Broad St over Abandoned RR Spur Bridge Replacement Project Narrative

The application for **UDC 2023-012 CONCEPT AMENDMENT location, character, extent review of the replacement of a bridge on E. Broad Street; 1554 E. Broad Street** was reviewed by the Urban Design Committee, on February 9, 2023, and <u>approved</u> by the City of Richmond Planning Commission, on February 21, 2023, with the conditions of approval listed below.

| | | PROJECT REVIEW COMMENT AND RESOLUTION SHEET | CODES: A. ACCEPT COMMENT—WILL BE CORRECTED, A B. DESIGNER WILL EVALUATE. C. DELETE COMMENT D. DEPARTMENT TO EVALUATE. E. INFORMATIONAL/NEXT PHASE REQUIREMEN | | |
|---|--------------------------|---|--|---|--------------------------|
| | on: E. Broad | REVIEW PHASE & TYPE: PRELIMINARY PLAN SUBMITTAL, 90% | 6 PLANS | DISCIPLINE: URBAN DESIGN COMMITTEE | CRM: (IF REQUIRED) |

E. BROAD STREET OVER ABANDONED RR SPUR (127-1852) SUPERSTRUCTURE REPLACEMENT

E. BROAD STREET TUNNEL PROPOSED PHOTOMETRIC PLAN CUT SHEETS

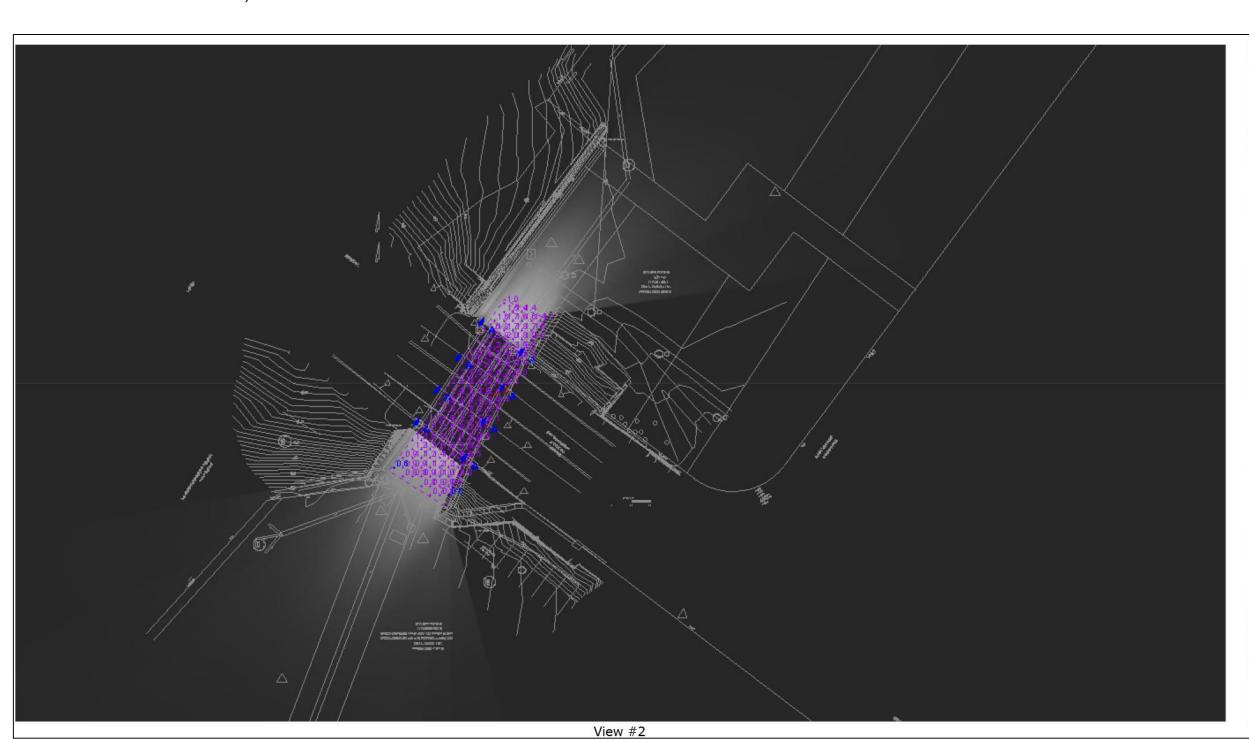
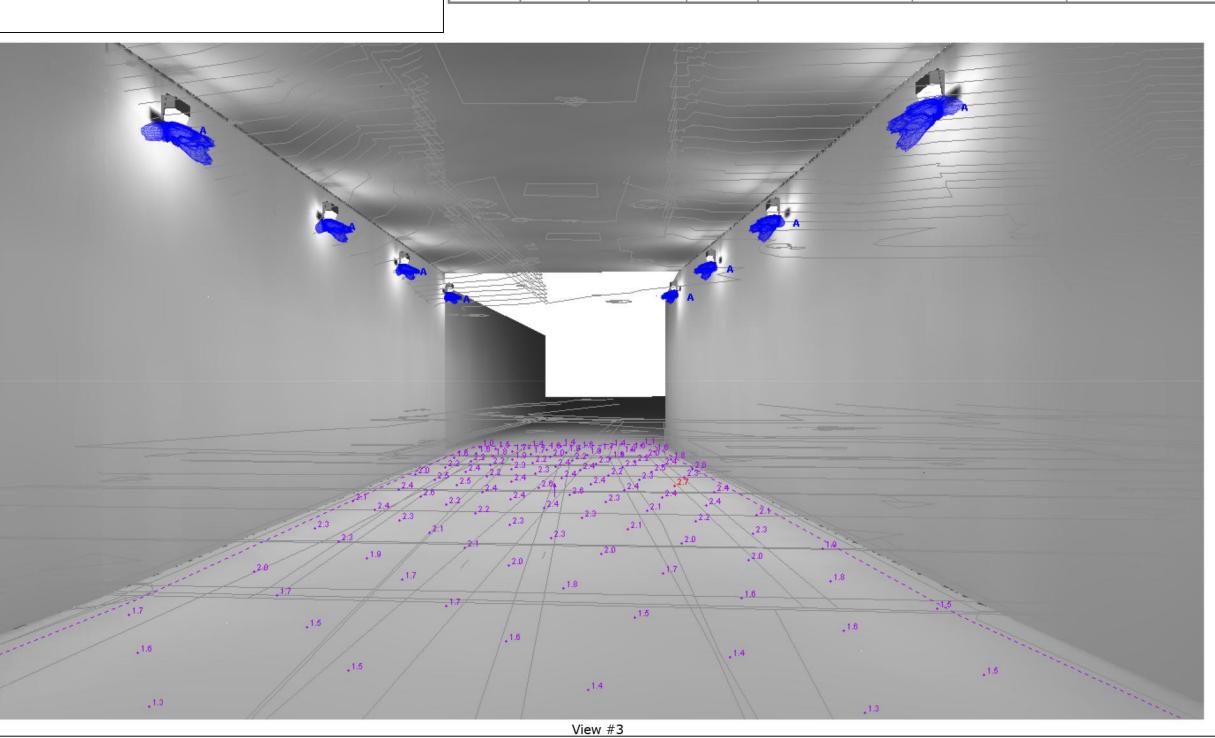
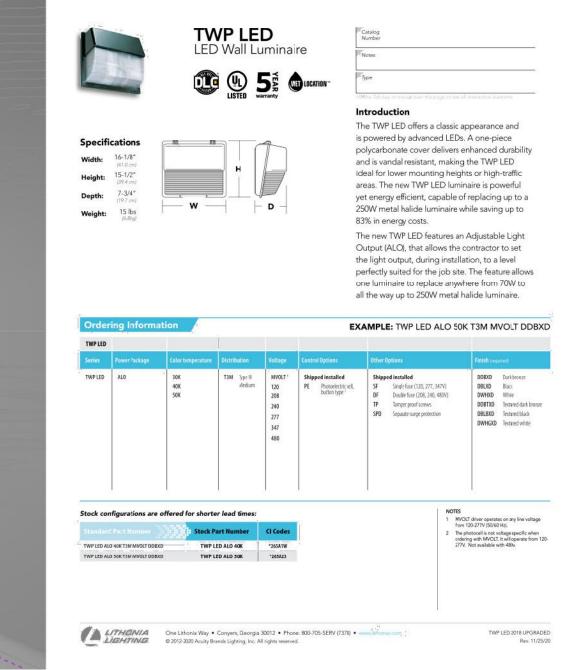
| 5. | G | Applicant to note on plans that any existing historic materials will be protected during construction, including existing masonry abutting the existing wingwalls on the southern side of the bridge – for FINAL submission. | A | A note has been added to the General notes on sheet 2 that any existing historic materials will be protected during construction, including existing masonry abutting the existing wingwalls on the southern side of the bridge. | |
|-----|---|--|---|--|--|
| 9. | G | Applicant to show on plans that lighting be provided within the pedestrian culvert. Exhibits on lighting and finishes to be submitted to UDC for FINAL submission. | А | Plans show photometric plans for the lighting within the pedestrian culvert. | |
